Re: 41 Salem St.

Planning Meeting May 21, 2020

May 19, 2020

I am writing with major concerns to the proposed amount of grade (FILL) that is being asked for approval by Bonza Builders LLC, for construction of 3 single family condo units on 41 Salem St

Inspection & Maintenance Checklist/ Log

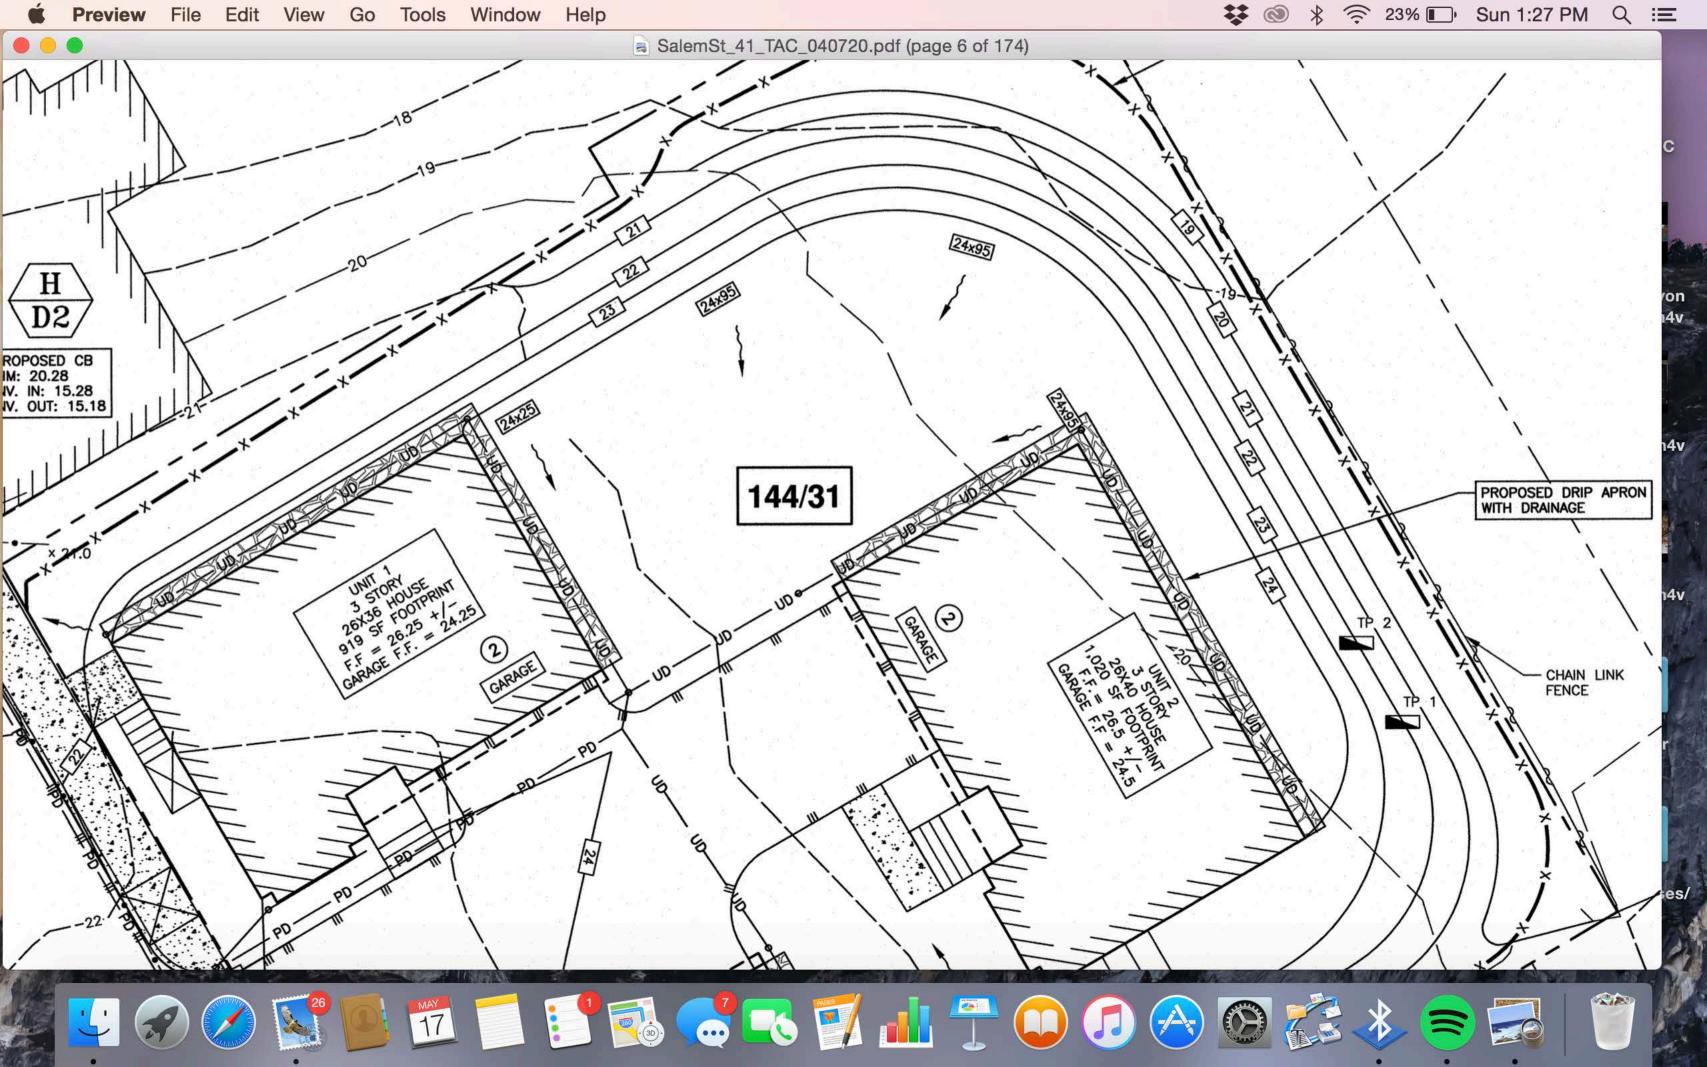
"This is a guideline..." Who is held responsible for these actions in 3, 5, 8 years in the future?

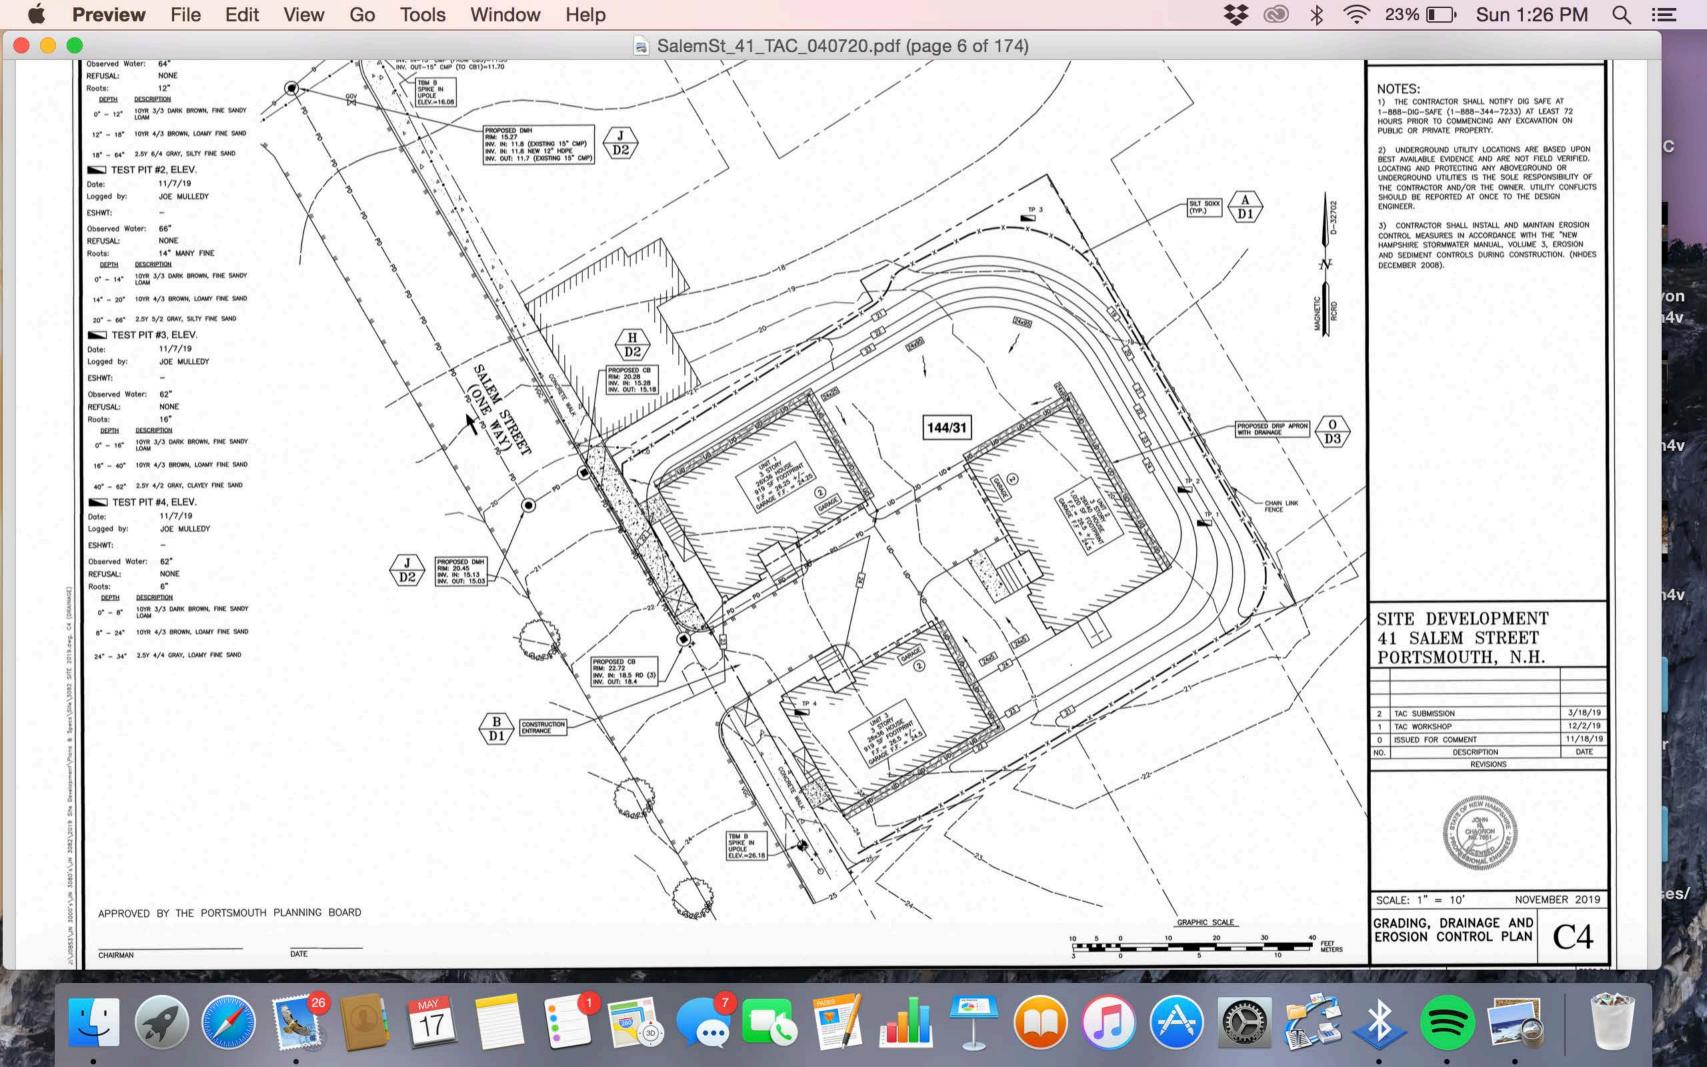
Due to these numerous contentious points, I would ask that another method of storm drain runoff be considered with less impactful ramifications to abutting properties.

Could the storm runoff pipes connect to the street farther down Salem St., thereby reducing the grading gain by 2 feet?

If the board approves this proposal, I would ask for language to assure neighboring properties that the Stormwater Inspections & maintenance plans be upheld for a period of no less then 4 years., and some type of horizontal architectural 2nd flr trim be added to reduce the massing of these buildings in regard to abutters views.
